Summit County Planning Commission (SCPC)

Thursday, April 25, 2024 - 3:00 p.m.

Meeting Agenda

Planning Commission
 Preliminary Plan
Swan Lake
 Copley Township

REVISED PRELIMINARY PLAN FOR SWAN LAKE SUBDIVISION PART OF O.L. 10 TOWNSHIP OF COPLEY COUNTY OF SUMMIT STATE OF OHIO

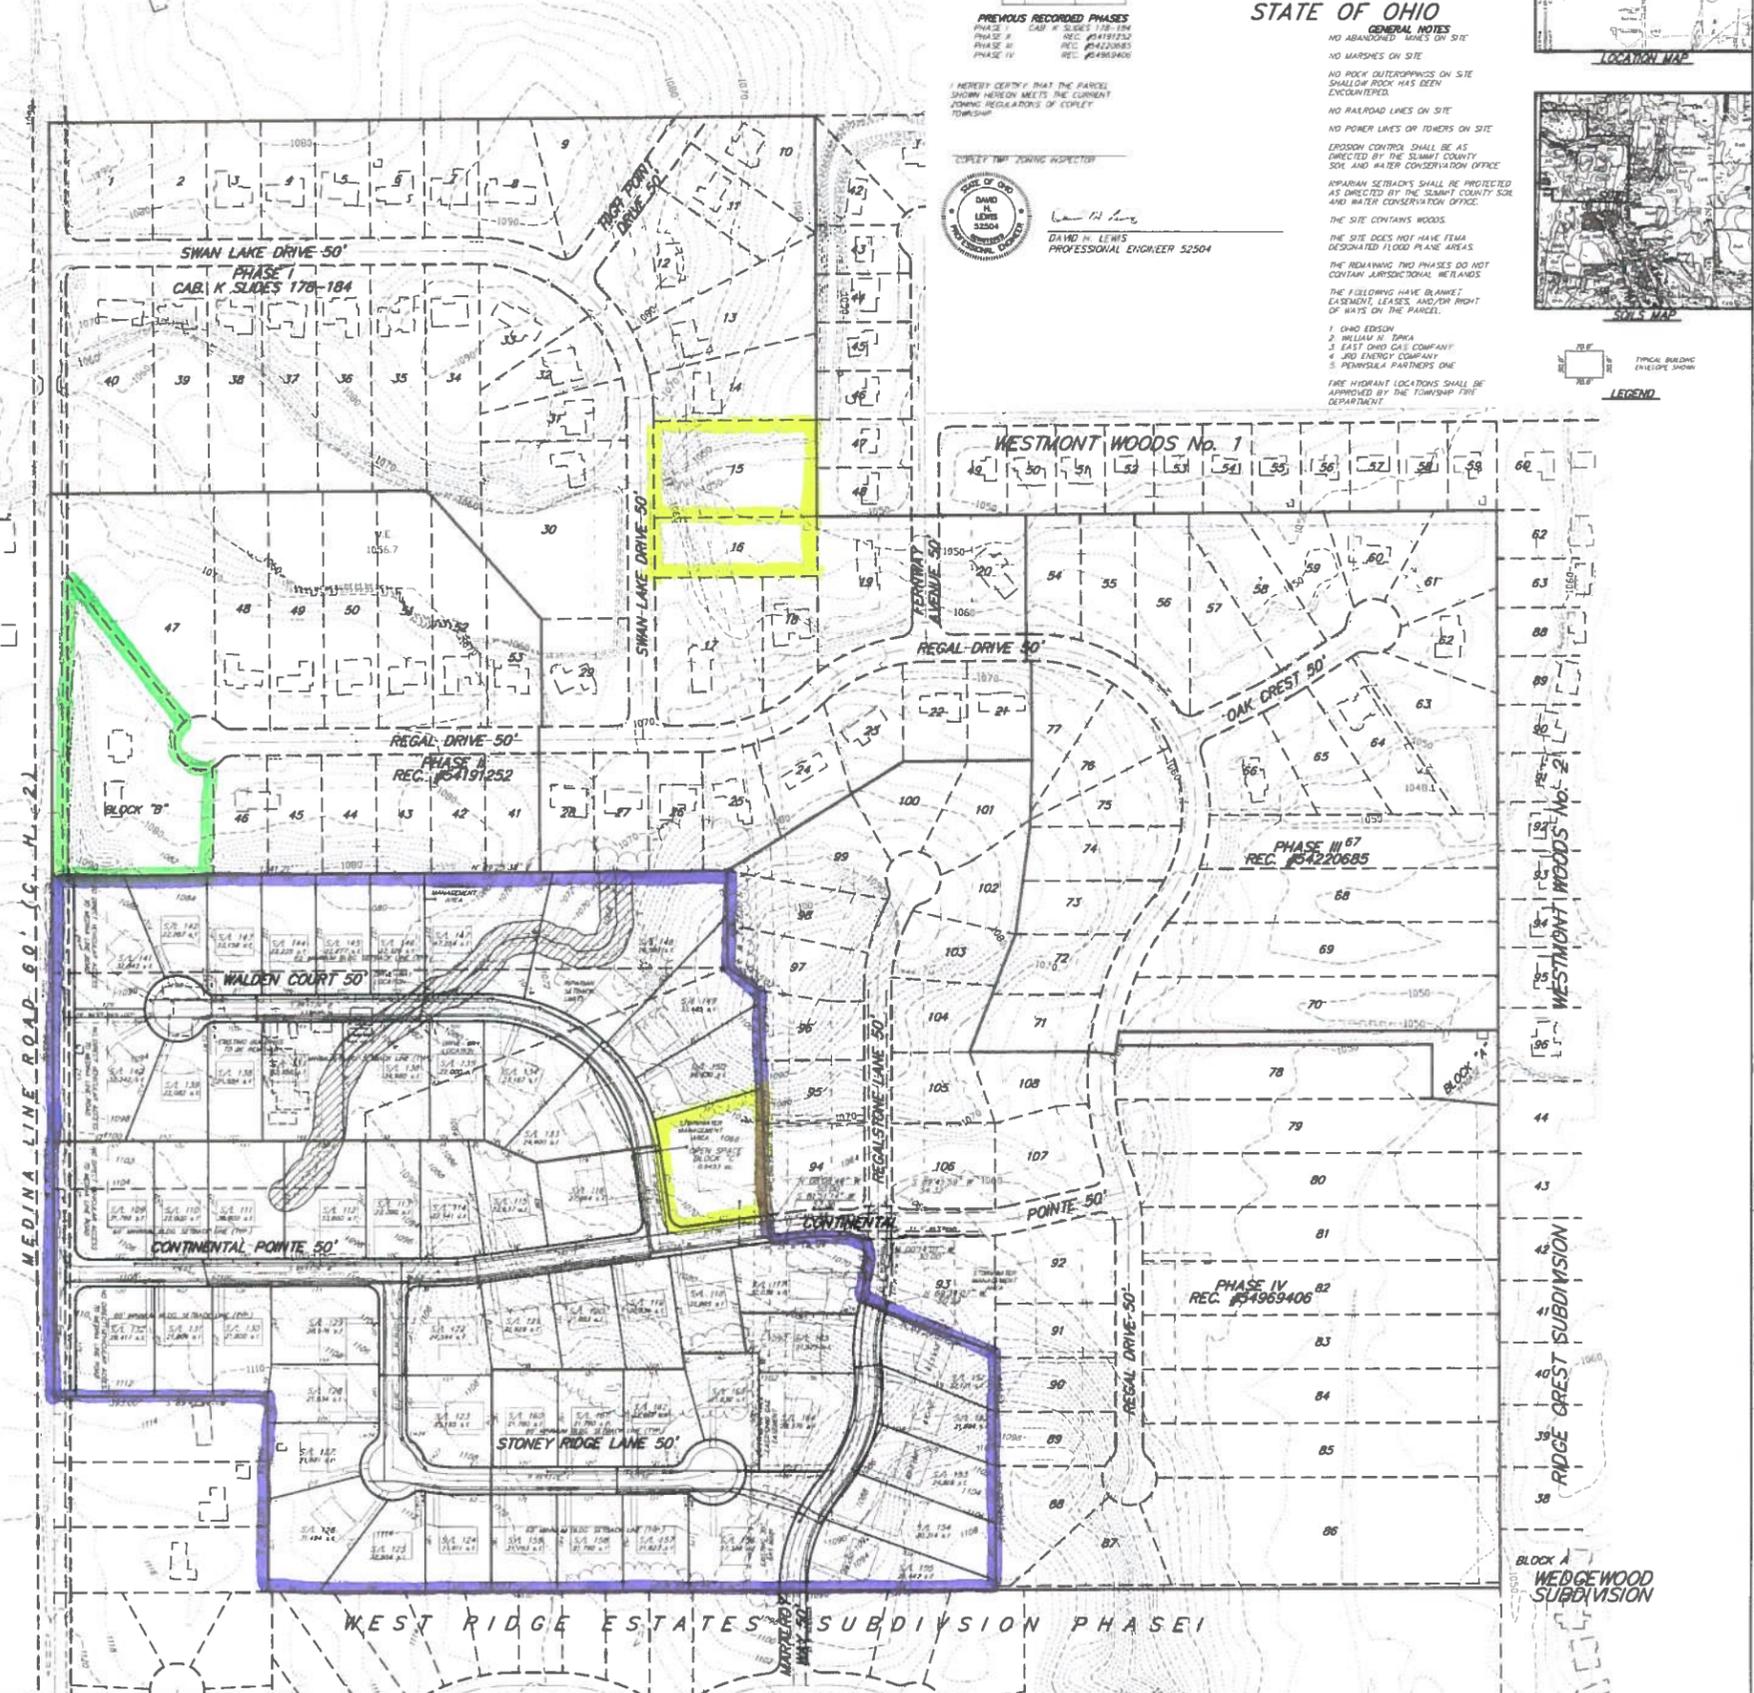
Staff recommendation is disapproval of the plan as they do not meet the current subdivision regulations requirement for open space. An open space would be in a block reserved for open space per subdivision regulations a change to the lots or blocks on an approved preliminary plan would require it to be returned to

Knittel answered from the table they need roughly 3.3338 ac. in the open space and the current is 0.905 ac. they are roughly 2 acres under.

Our office has reviewed the above referenced and attached Preliminary Plan and has the following comments. If you have any questions regarding this matter, please contact our office.

3. *All Stormwater Management for the site must follow the SCE Stormwater Drainage Manual, Current Edition (Revised 1/1/20). All SWM Facilities must be located outside of the Wetland and Riparian Setback. In addition, adequate outlets must be provided for the Proposed Basins.*

6. *The Intersection Sight Distance for proposed access onto Medina Line Road must be verified for a Design Speed equal to 50-mph.*
7. *A Traffic Impact Questionnaire for the project must be completed to determine if additional Studies are warranted.*

Recommendation: Staff recommends **CONDITIONAL APPROVAL** of the Swan Lake Preliminary Plan with conditions to meet the Summit County Engineer’s Office comments.

SWAN LAKE SUBDIVISION
 REVISED PRELIMINARY PLAN

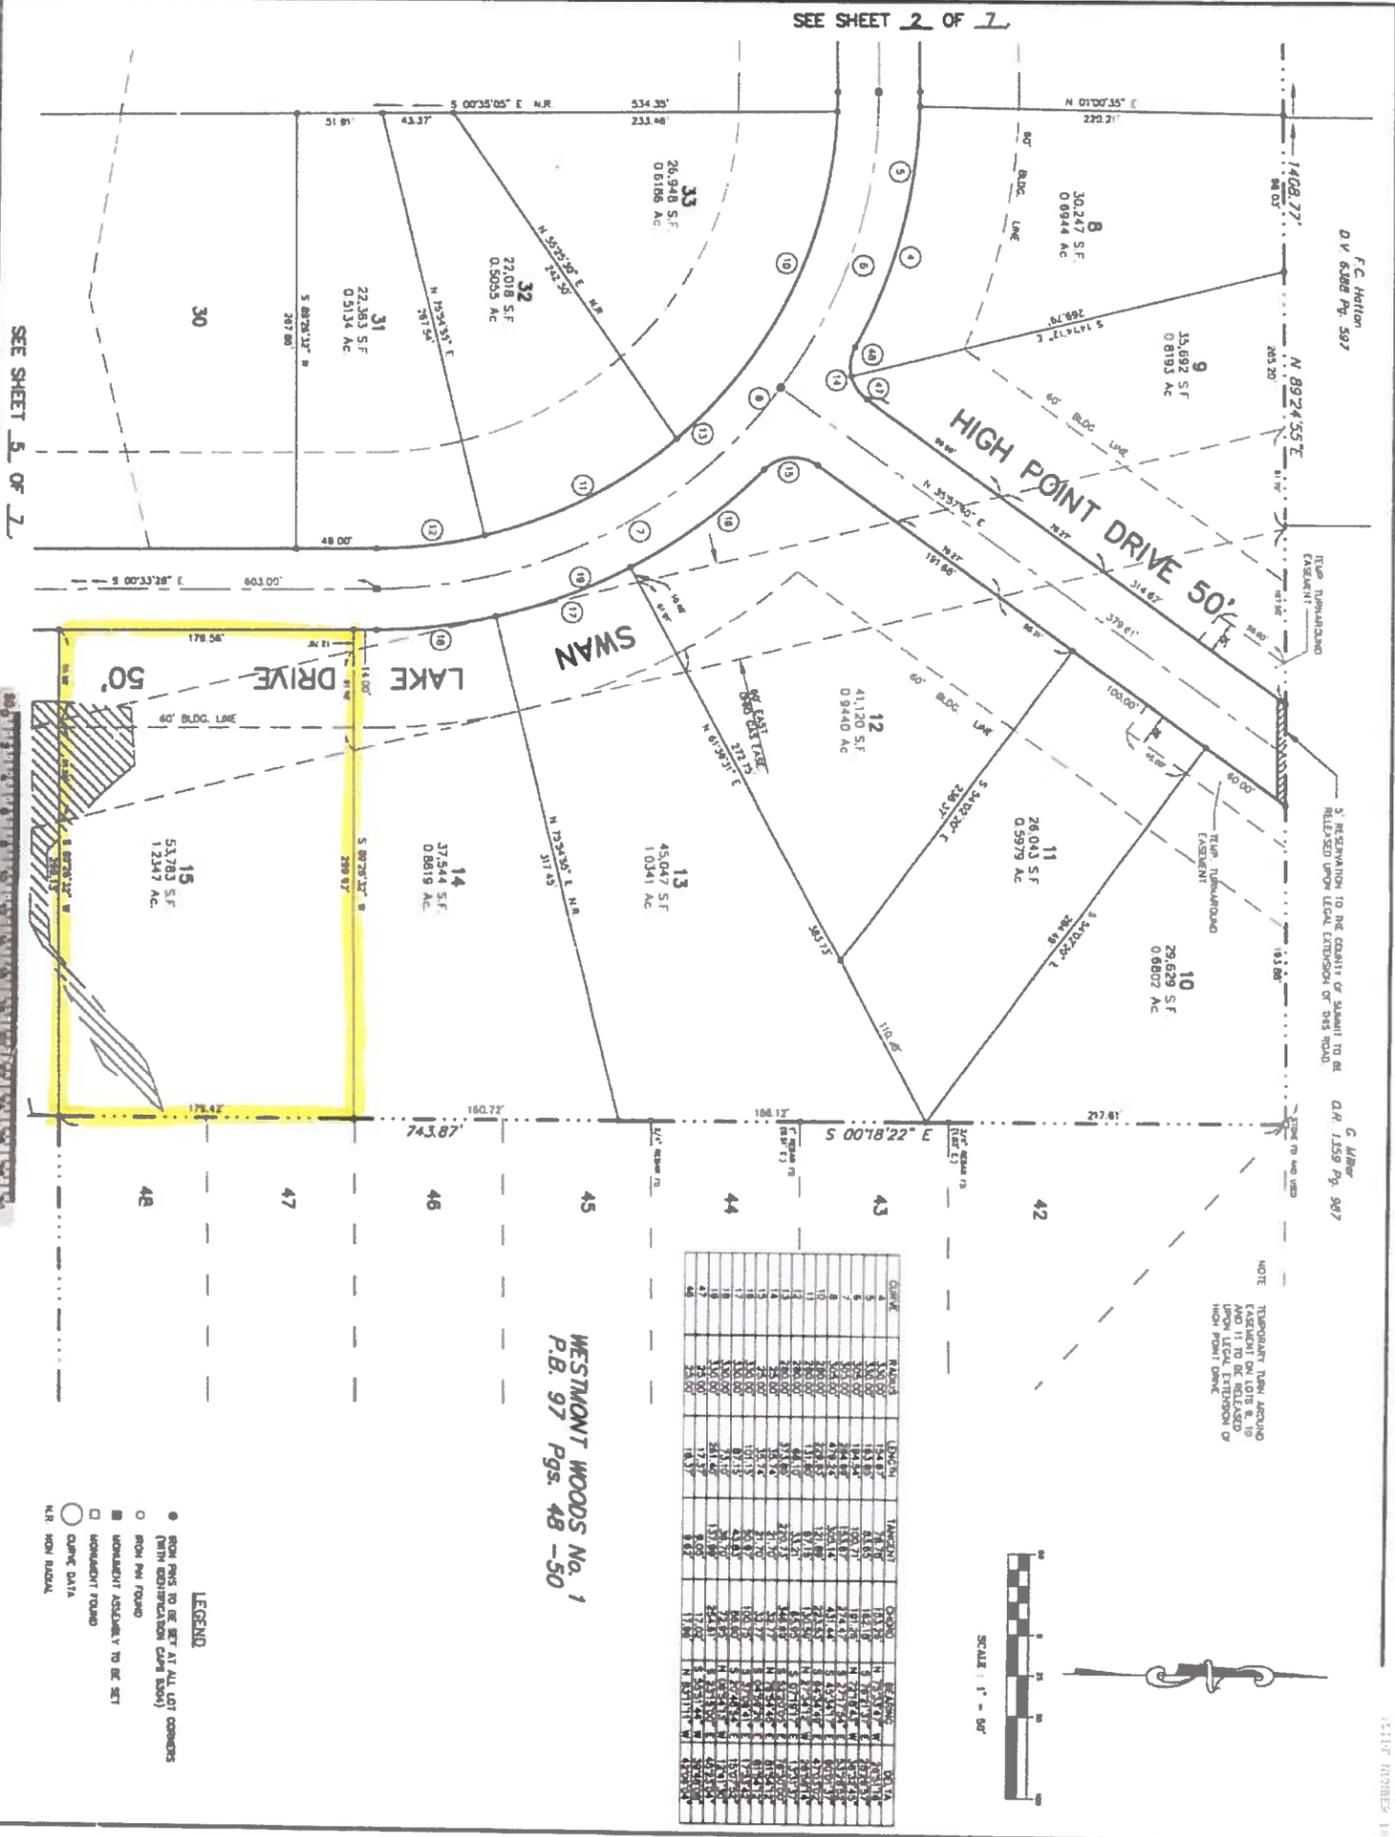
At this time, Dominion does not approve the above reference project as provided by your office on 11-27-2023. For Dominion to continue with the approval process, please review the attached requirements set forth in this correspondence and make necessary corrections to the plans previously submitted to this office for Dominion's review and approval. No construction may take place until approval is granted.

- All facilities and easement areas, if applicable, will be depicted, dimensioned, and identified on all survey plats, improvements, development plans and plats. Where Dominion holds undefined rights, all plans and the final recordable plat will dedicate these areas as being restricted areas.

- When constructing third-party utility crossings between Dominion's high-pressure pipelines, a minimum vertical and horizontal clearance of two feet (2') must be maintained to reduce the risk of damage to Dominion's pipeline and related facilities. In addition to the review for conflicts with Dominion facilities and your project, Dominion will also need to review the plan, profile, and cross sections for the proposed improvements for said utility that crosses Dominion's pipeline. When crossing Dominion's high pressure pipelines the profile centerline should be based along the centerline of Dominion's pipeline. For Dominion's distribution pipeline, the profile centerline can be based along the centerline of the proposed roadway work. Use the standard scale of a vertical scale of 1 inch =5 ft and a horizontal scale of 1 inch =50 ft for your plan, profile, and cross sections.

Included in the profile and cross sections should be the existing and proposed grades, existing utilities, proposed road, and utility improvements, and Dominion's existing pipeline. The profiles and cross sections should be incorporated into your construction improvement plans.
